The Town of Hilton Head Island Regular Design Review Board Meeting

Tuesday, November 23, 2010

DESIGN TEAM/ DRB COMMENT SHEET

PROJECT Barony Beach Club

DRAWING
EXTERIOR ELEVATIONS

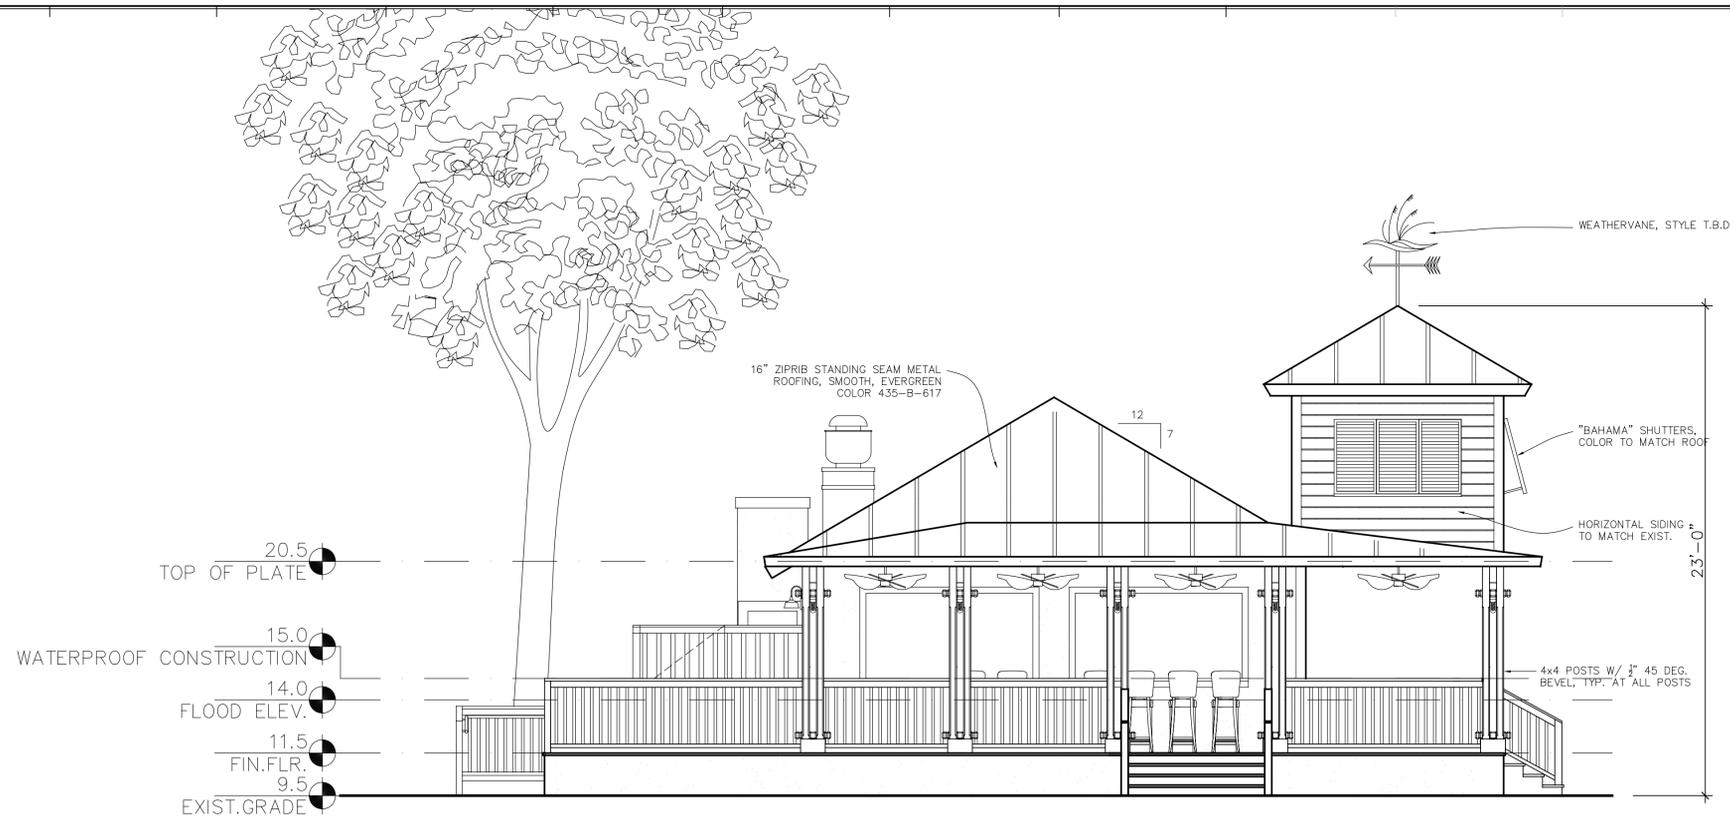
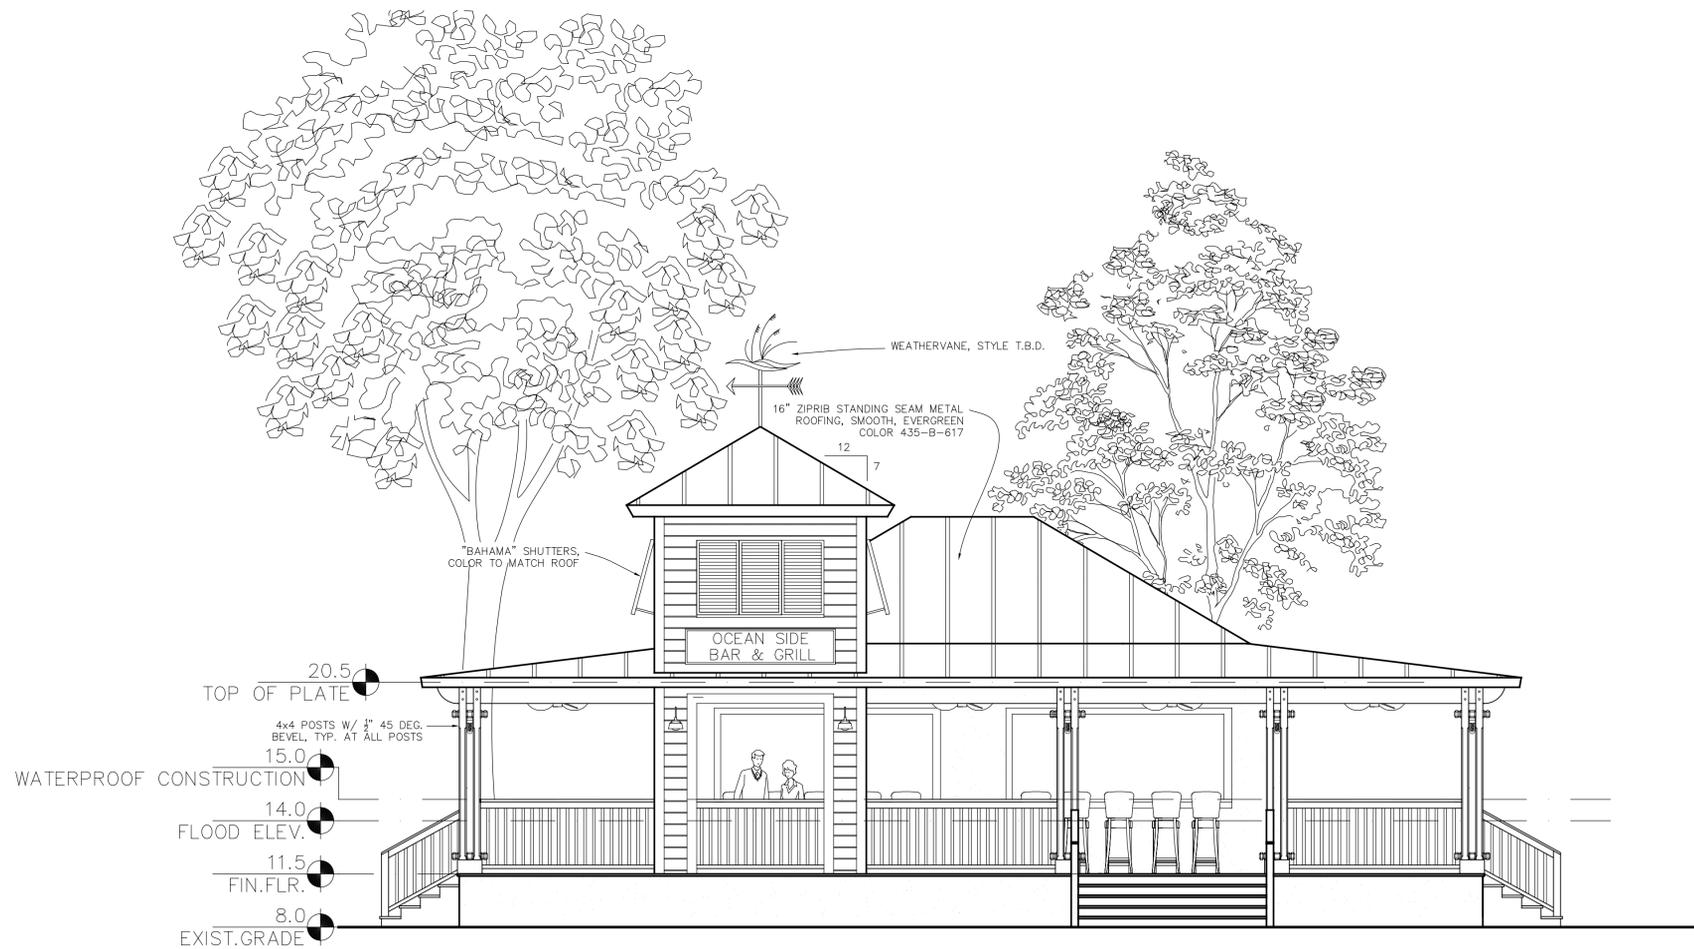
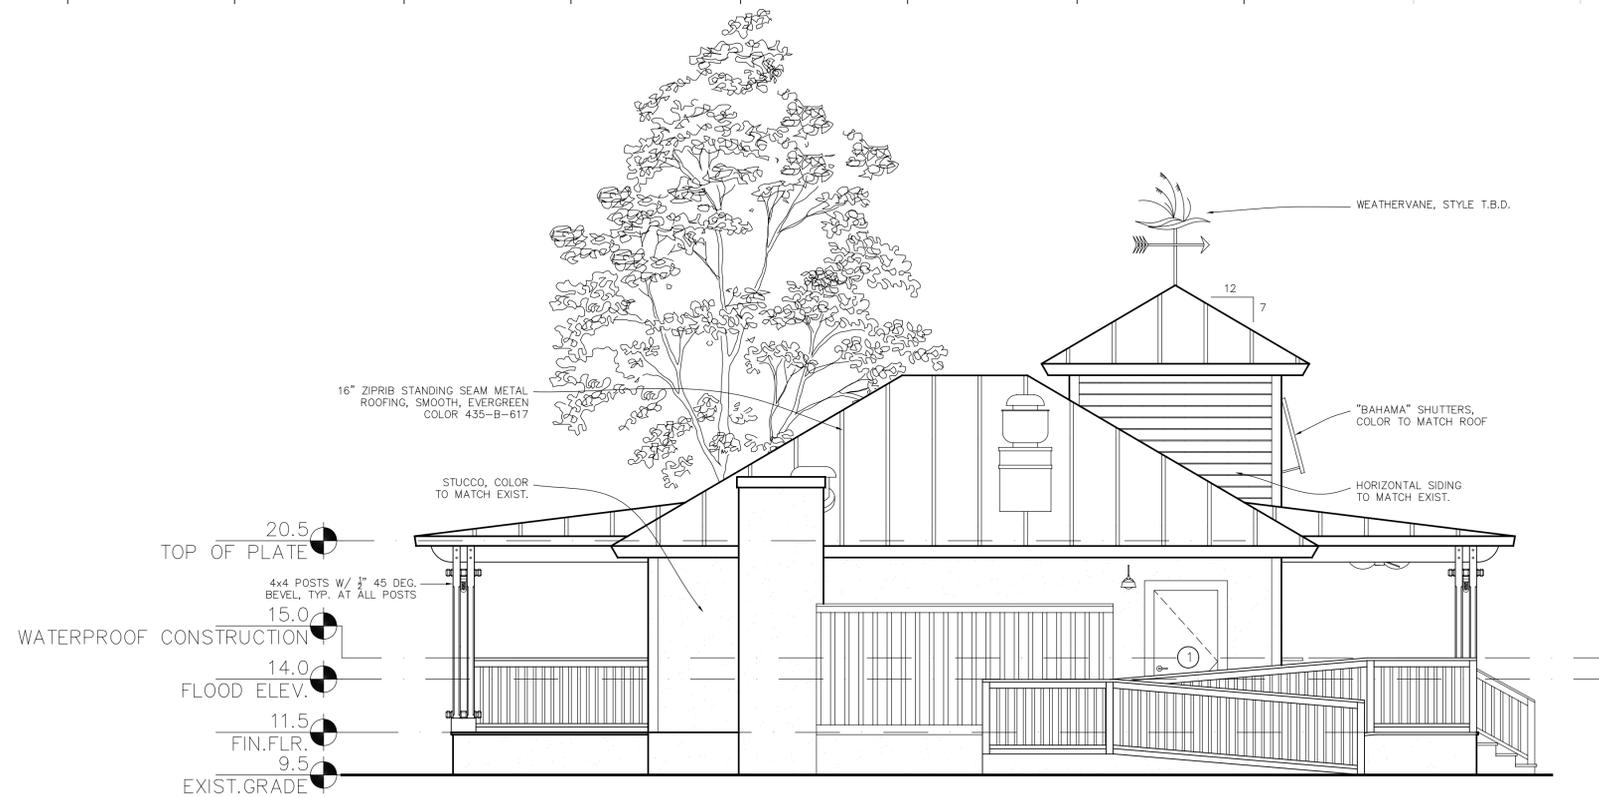
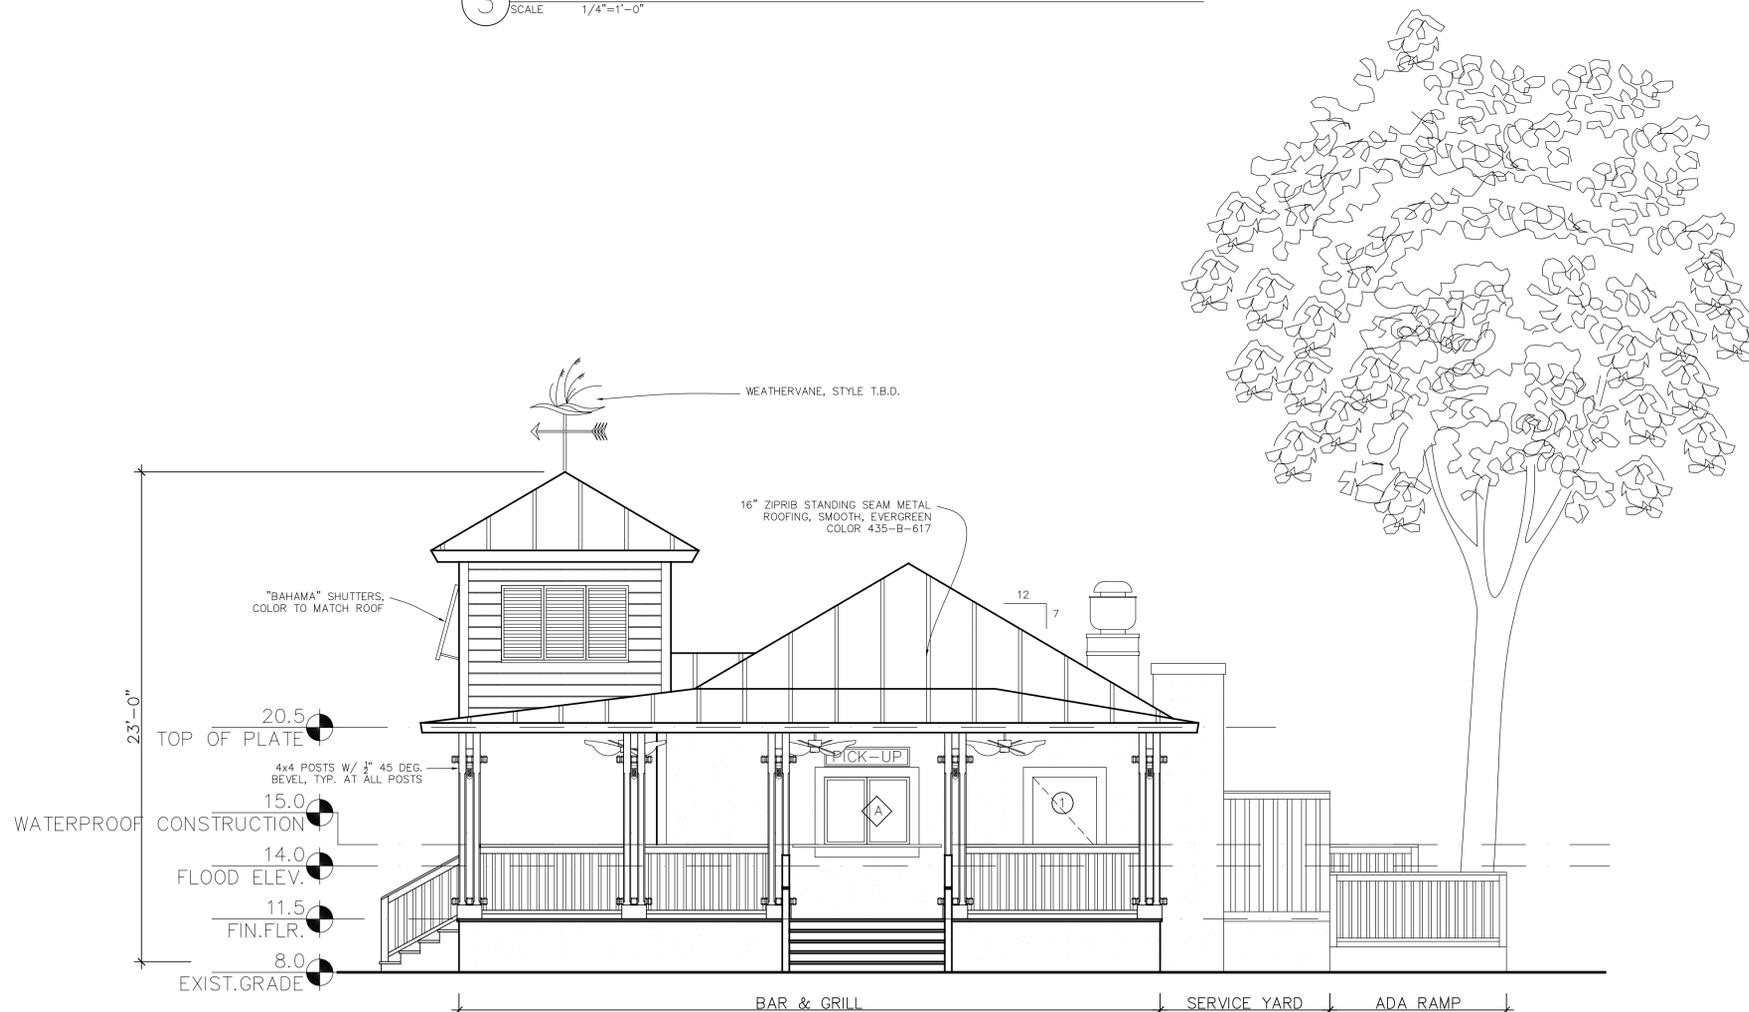
All conceptual comments have been addressed. Kitchen exhaust should be painted to match proposed roof color.

SITE PLAN

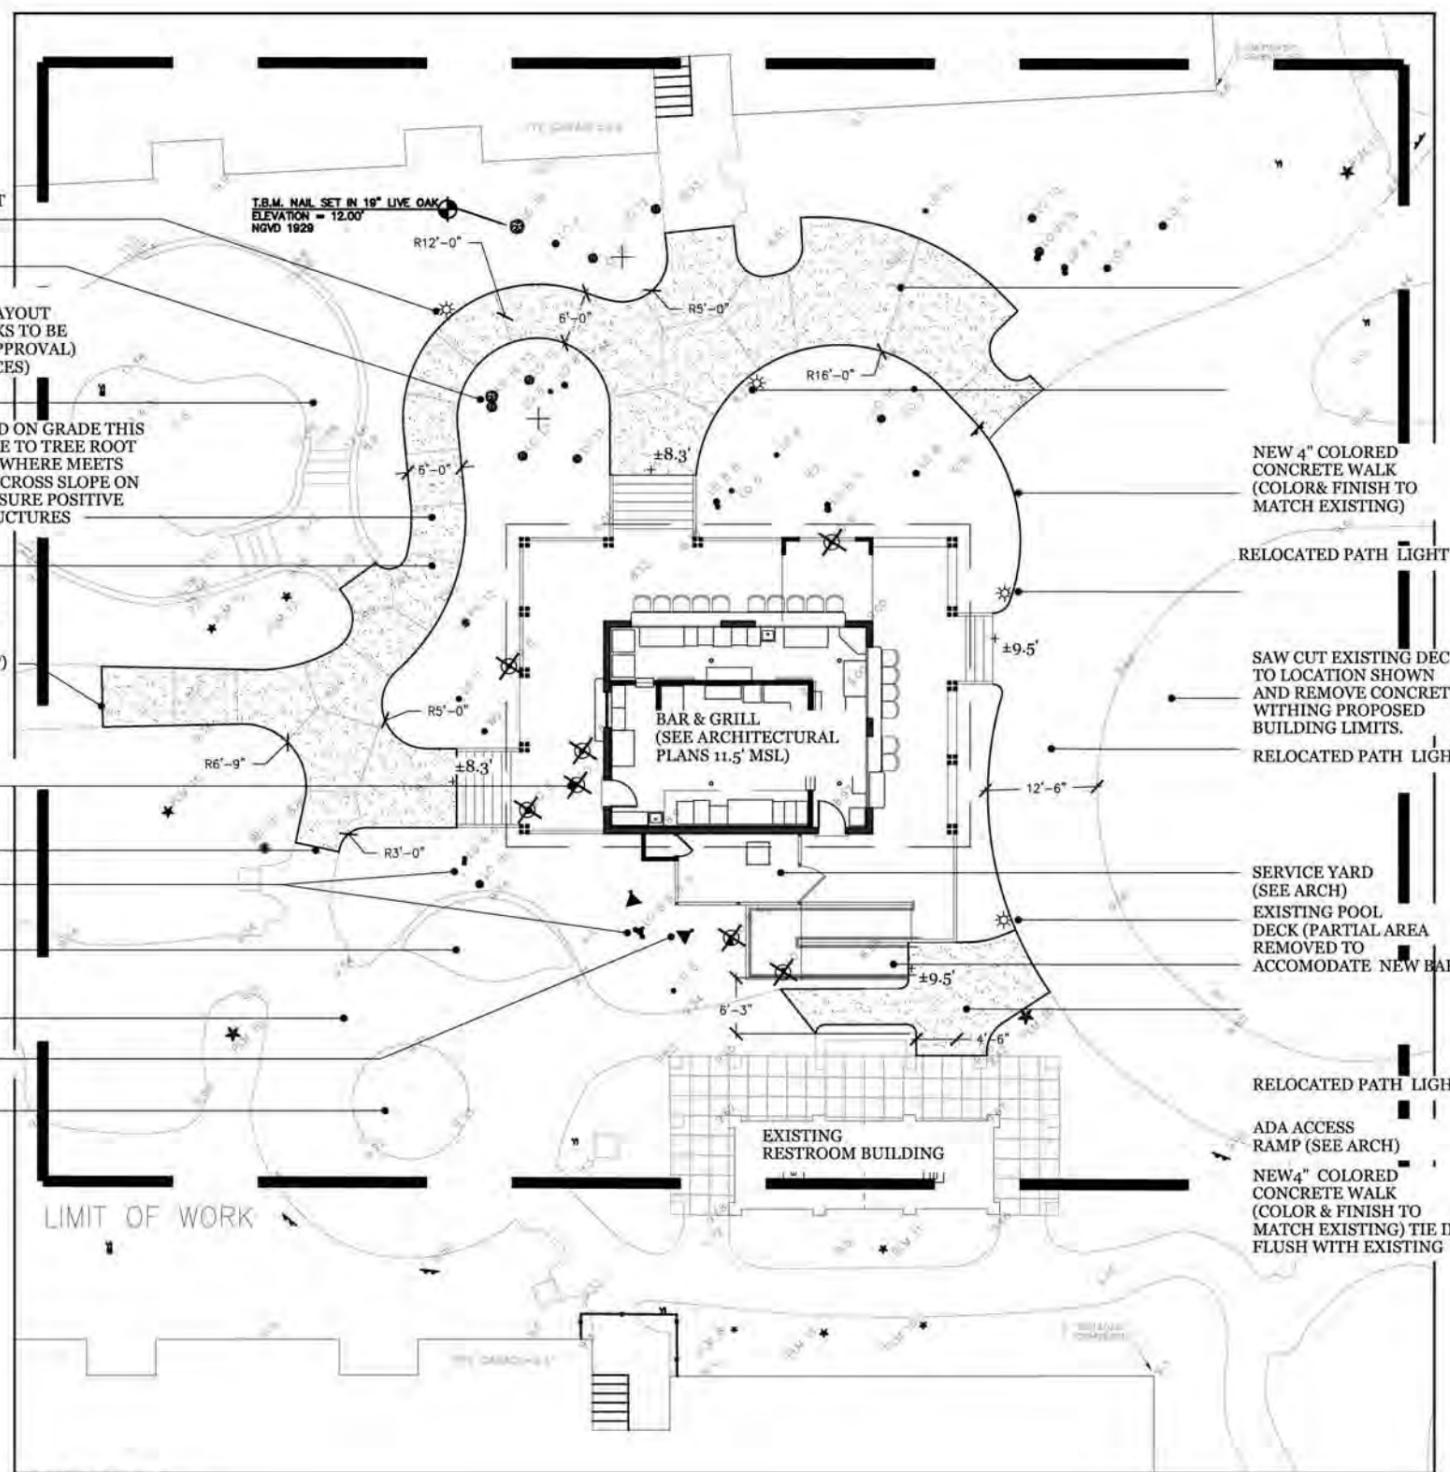
Sidewalk has been re-routed to eliminate tree removal concerns. Very good planting plan
